35/1~~3~~³-06GG 37 OXFORD ST
Chevy Chase Village Historic District

SUBJECT: Historic Area Work Permit #385729 ^{438933 NEW#} REVISION, driveway alterations

HISTORIC PRESERVATION COMMISSION STAFF REPORT

Address:	37 Oxford St, Chevy Chase	Meeting Date:	12/6/2006
Resource:	Contributing Resource Chevy Chase Village Historic District	Report Date:	11/29/2006
Applicant:	Bruce Becker & Natalie Jennings	Public Notice:	11/22/2006
Review:	HAWP	Tax Credit:	N/A
Case Number:	35/13-06GG	Staff:	Michele Oaks
PROPOSAL:	Driveway Alterations

JENNINGS/ BECKER RESIDENCE
 37 OXFORD STREET
 CHEVY CHASE, MARYLAND
 DATE: JUNE 1, 2005 SCALE: 1/8"=1'0"

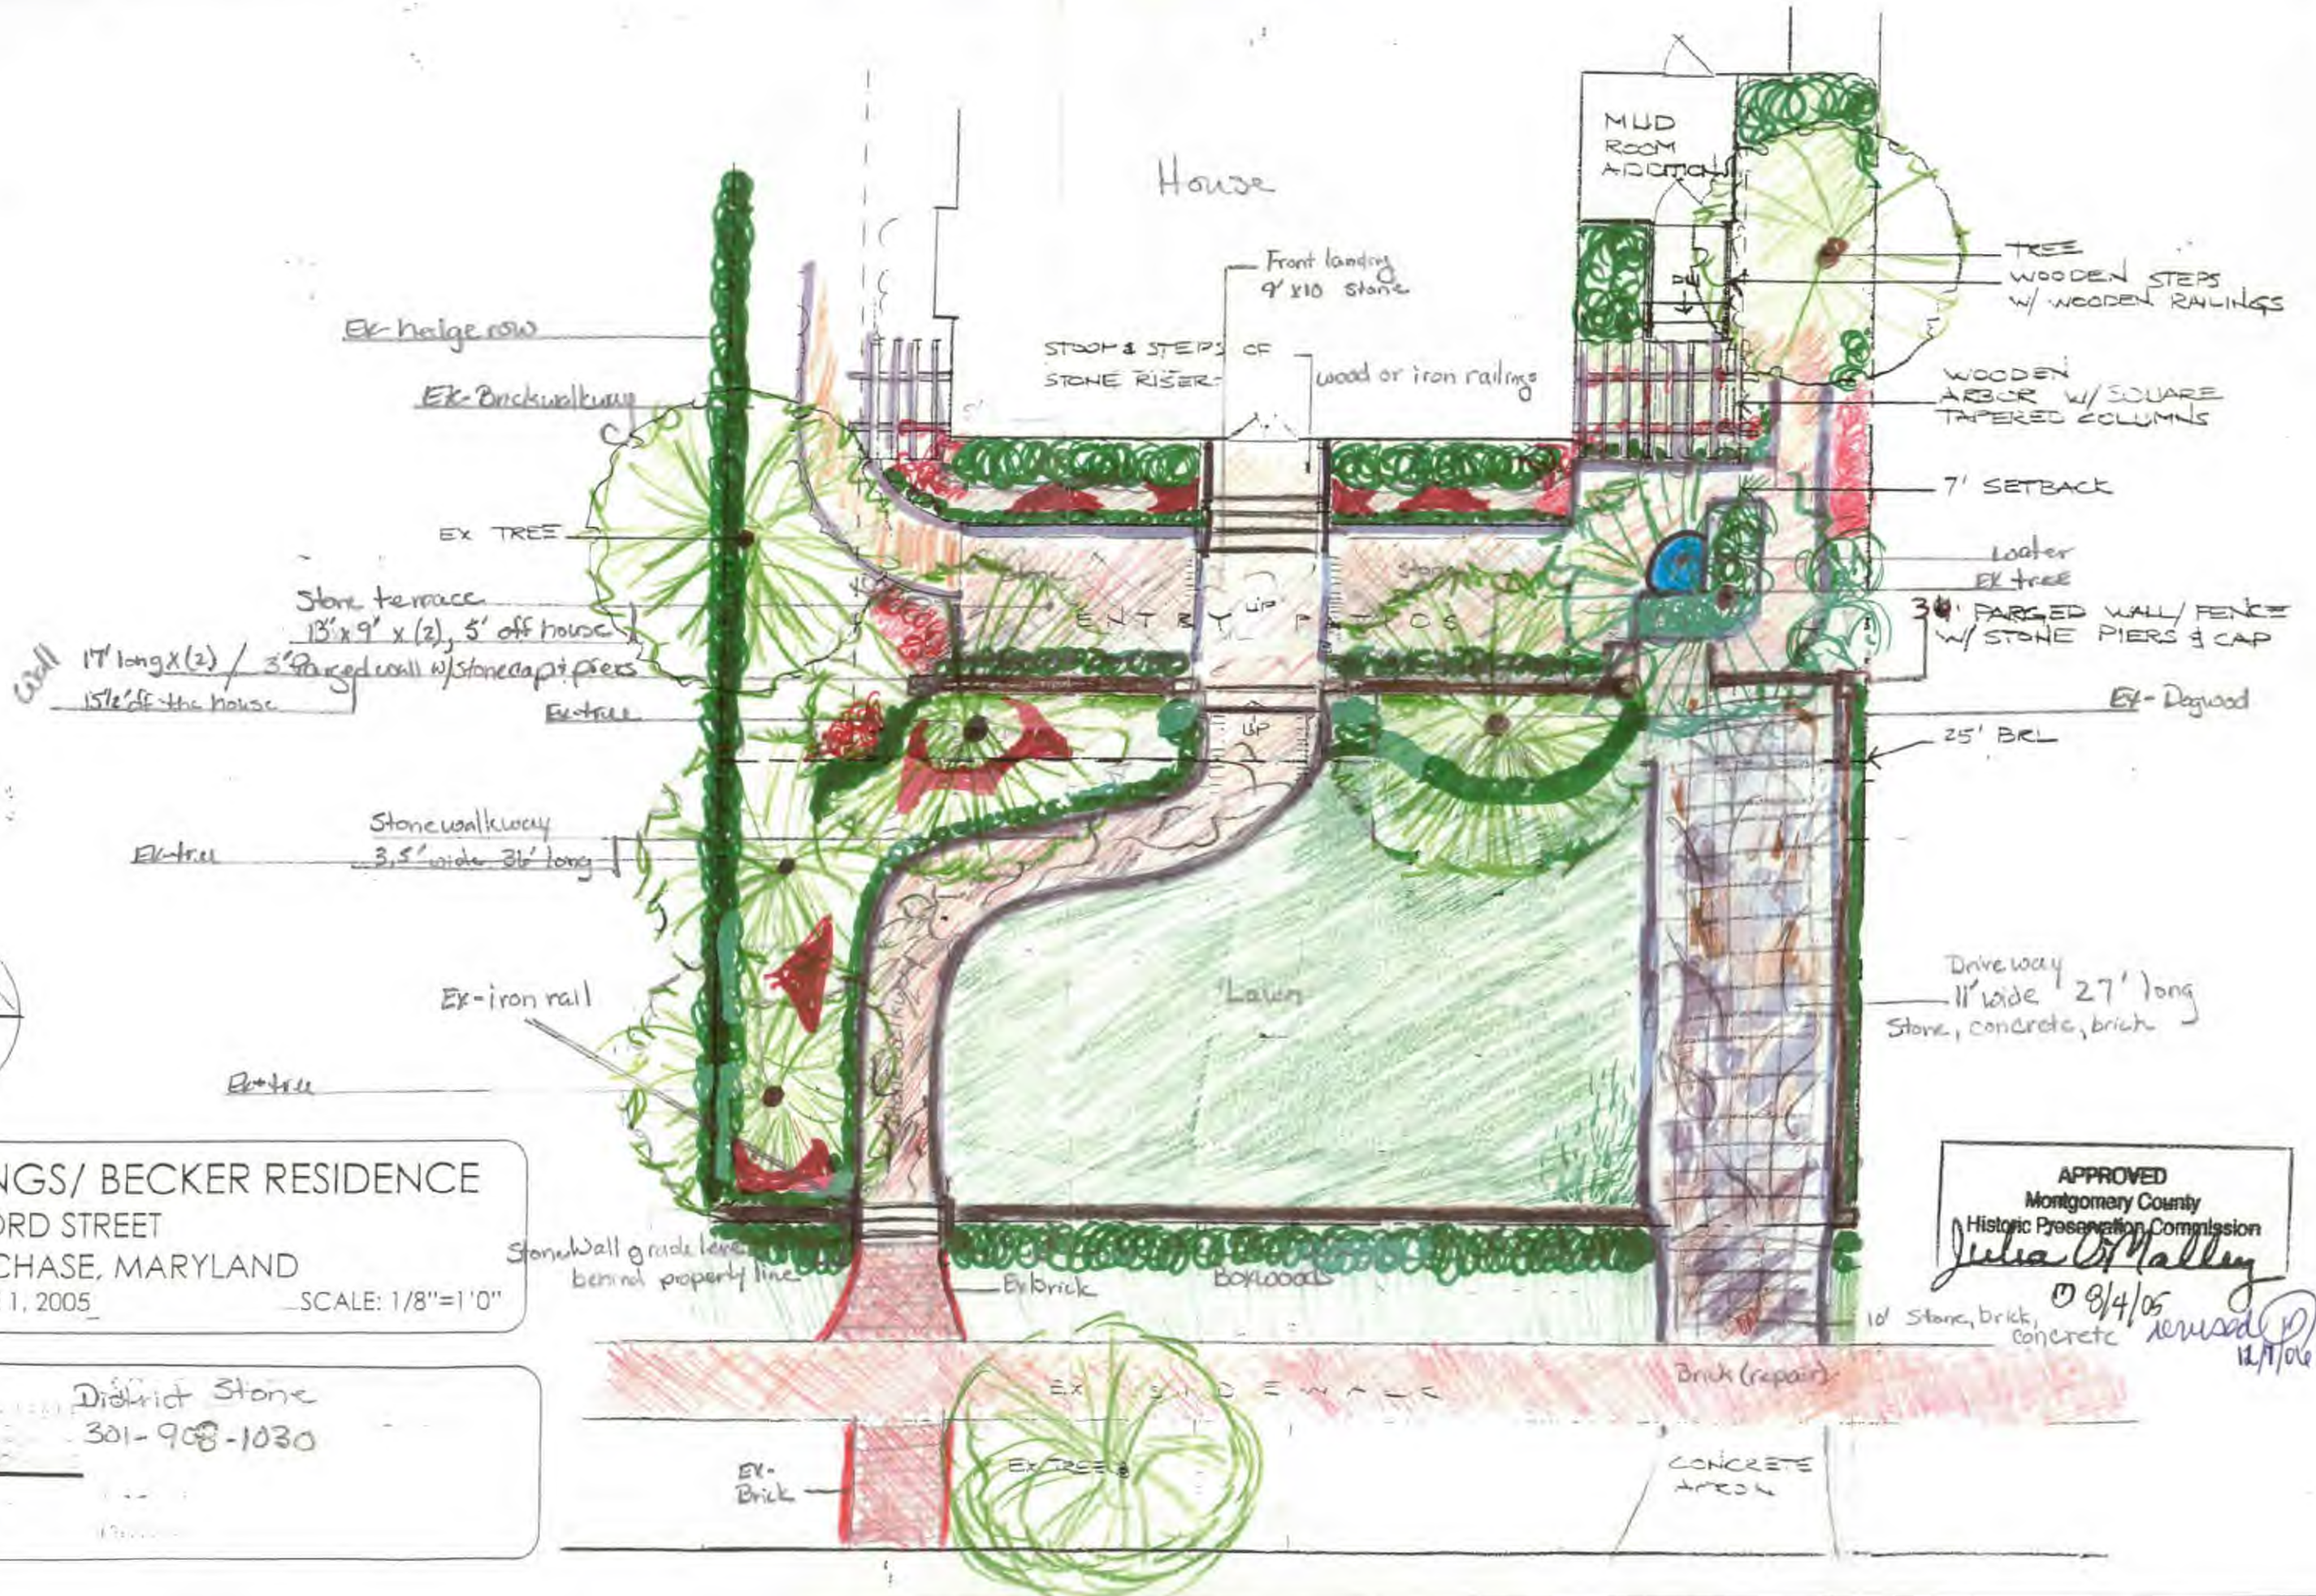
On the drawing stamped 8/4/05 showed a parking pad and driveway rails with grass between the rails. Due to the slope of the yard and the level of the public sidewalk installing a driveway with rails is causing major drainage problems. We have tried several different options to fix the problem. We added a drain and re-sloped the driveway but water is still collecting between the rails and under the sidewalk.

Reinstall the driveway without rails which is back to the original state when the house was first built. (See attached photos and blue print drawings) This will fix the water management problem and will prevent us from having to do a major excavation project by lowering and expanding the driveway so you can get in and out of the car and building retaining walls to keep back the yard.

We will reuse original cobblestones and bricks and set them in concrete just like the way the house was originally built.

The 3' high parged wall/fence with stone piers and cap may move 6' closer to the front property line, however, the height of the wall/fence combination will not exceed 3' from grade to the top of the structure.

JENNINGS/ BECKER RESIDENCE
 37 OXFORD STREET
 CHEVY CHASE, MARYLAND
 DATE: JUNE 1, 2005 ...SCALE: 1/8"=1'0"

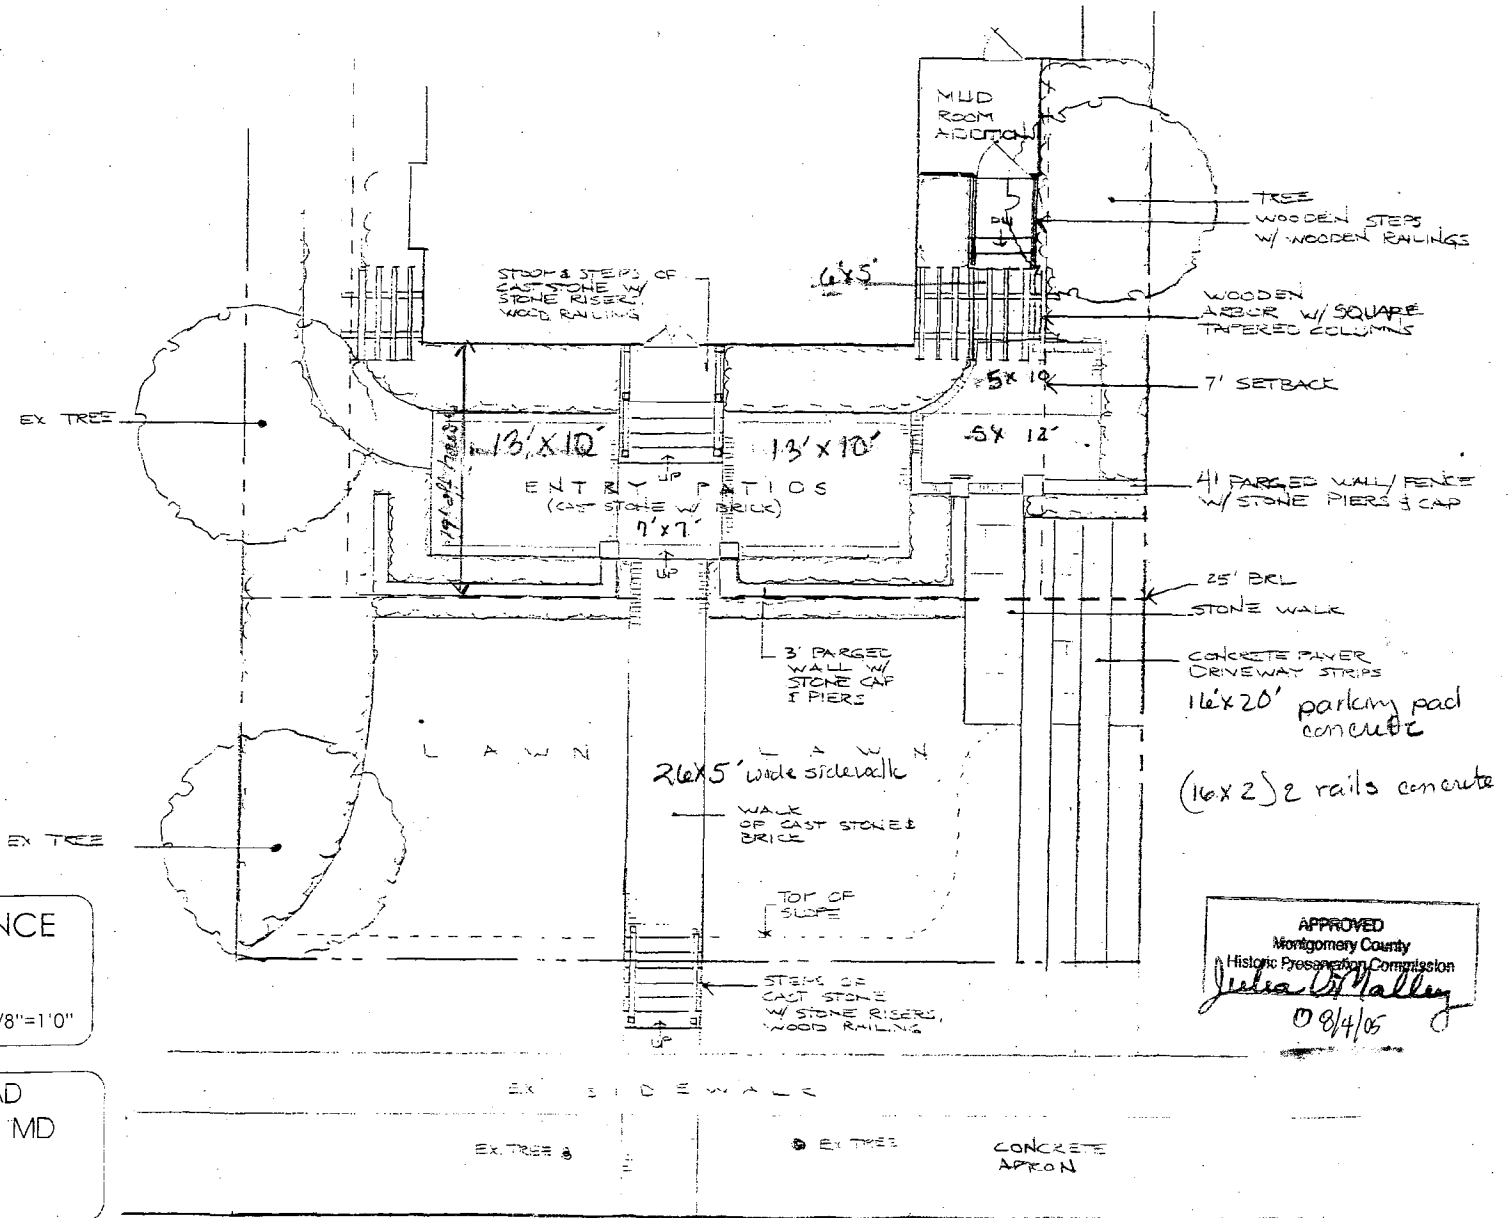
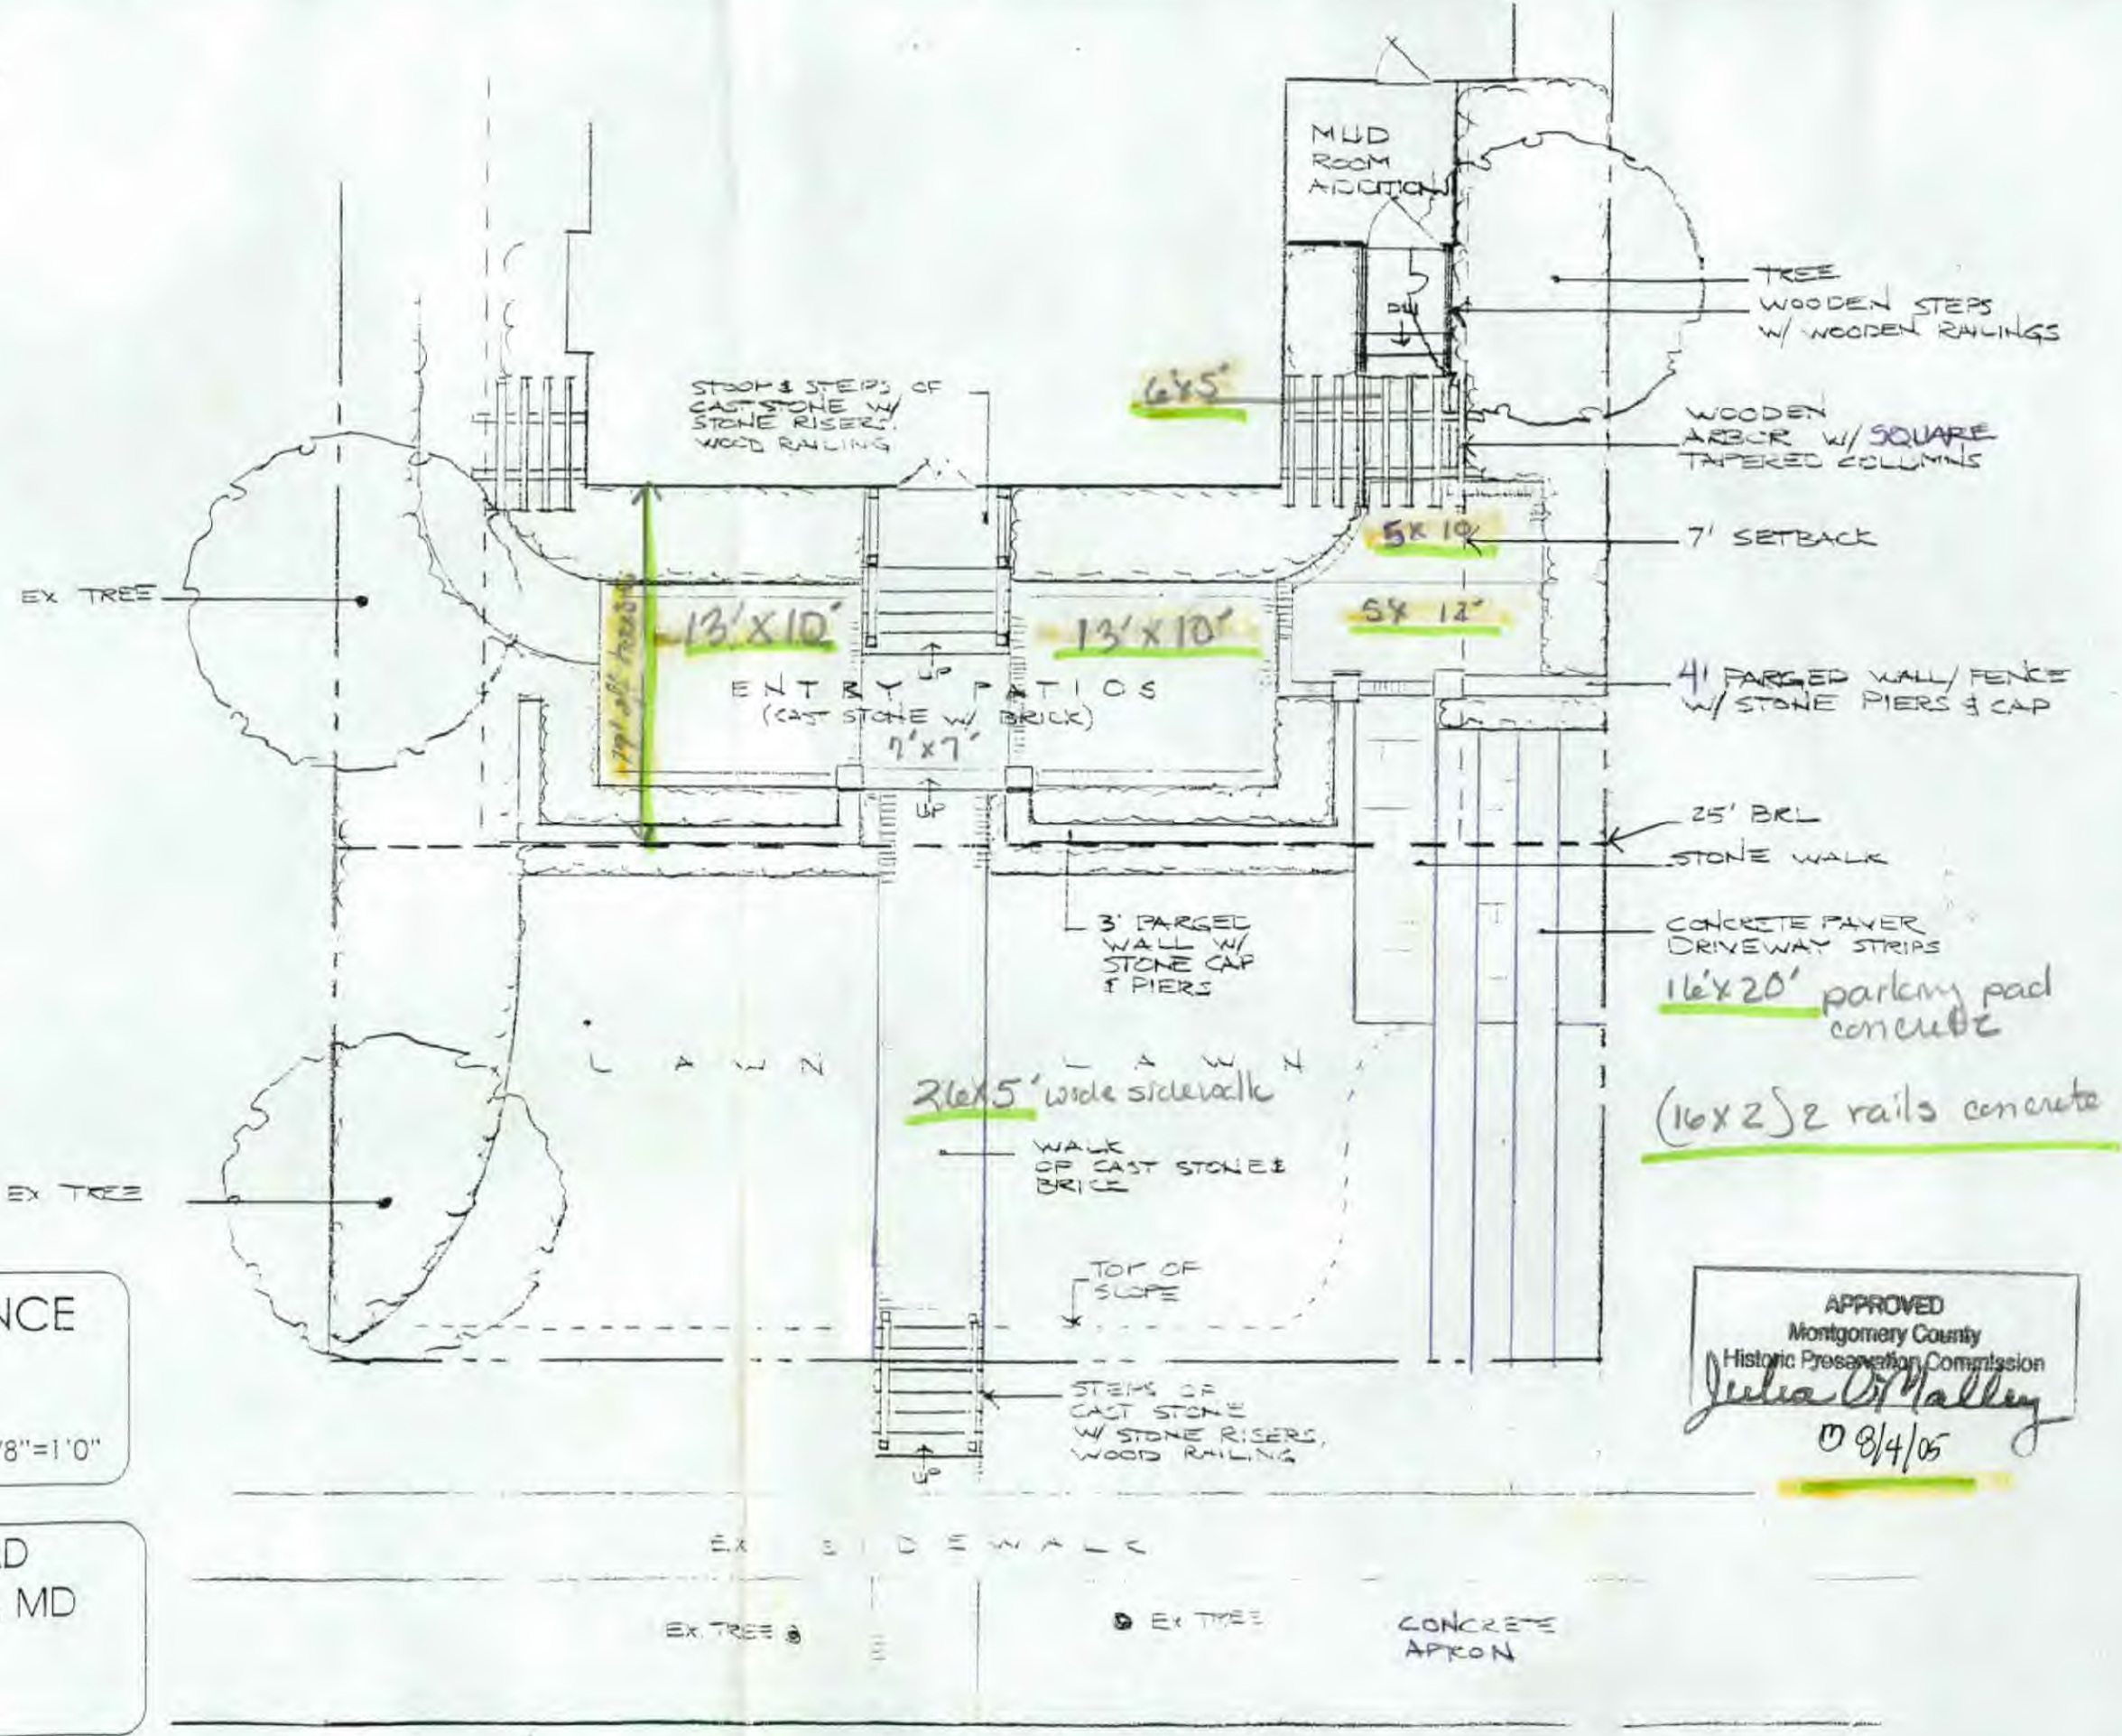
On the drawing stamped 8/4/05 showed a parking pad and driveway rails with grass between the rails. Due to the slope of the yard and the level of the public sidewalk installing a driveway with rails is causing major drainage problems. We have tried several different options to fix the problem. We added a drain and re-sloped the driveway but water is still collecting between the rails and under the sidewalk.

Reinstall the driveway without rails which is back to the original state when the house was first built. (See attached photos and blue print drawings) This will fix the water management problem and will prevent us from having to do a major excavation project by lowering and expanding the driveway so you can get in and out of the car and building retaining walls to keep back the yard.

The 4' high parged wall/fence with stone piers & cap may move 6' closer to the front property line, however, the height of the wall/fence combination will not exceed 4' from grade to the top of the structure.
